PCN-20190110a TE0820-03-* SPI Flash and eMMC Change

Company	Trenz Electronic GmbH
PCN Number	PCN-20190110a
Title	TE0820-03-* SPI Flash and eMMC Change
Subject	BOM change
Issue Date	2019-10-02

This change affects Trenz Electronic TE0820-03 SoMs: TE0820-03-*

Locate Flash (U7, U17) on top side of PCB and eMMC (U6) on bottom side of PCB:

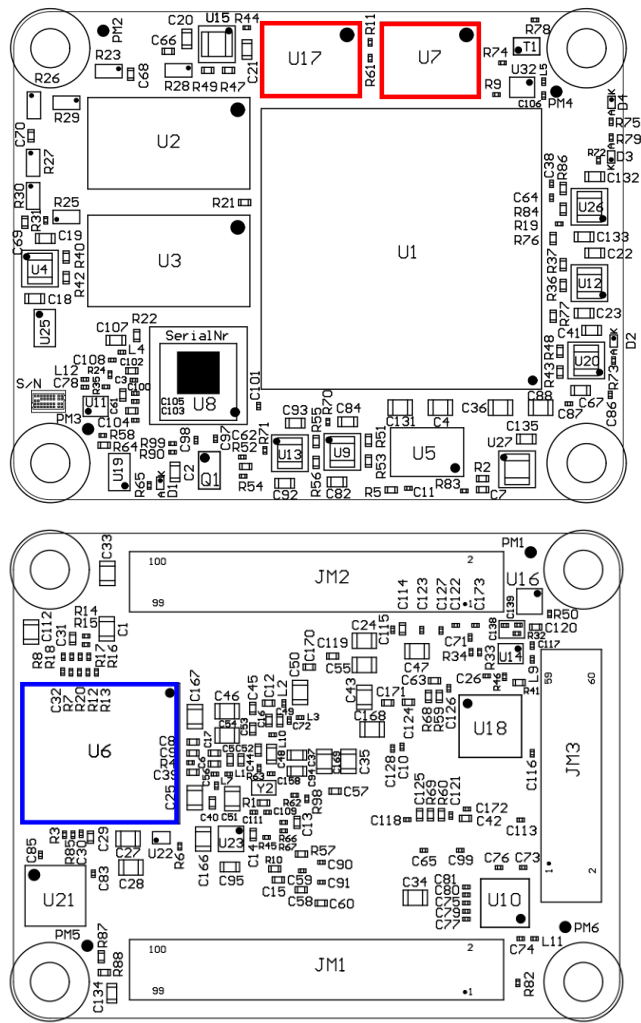
#1 Change SPI Flash from N25Q512A11G1240E to MT25QU512ABB8E12-0SIT

#2 Change eMMC from MTFC4GACAJCN-4M IT to IS21ES08G-JCLI

Impact: The eMMC capacity changed from 4 GByte to 8 GByte.

old	new
N25Q512A11G1240E	MT25QU512ABB8E12-0SIT

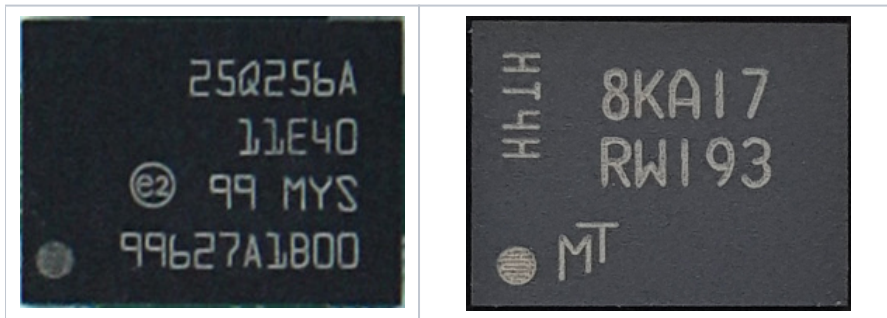
MTFC4GACAJCN-4M IT	IS21ES08G-JCLI
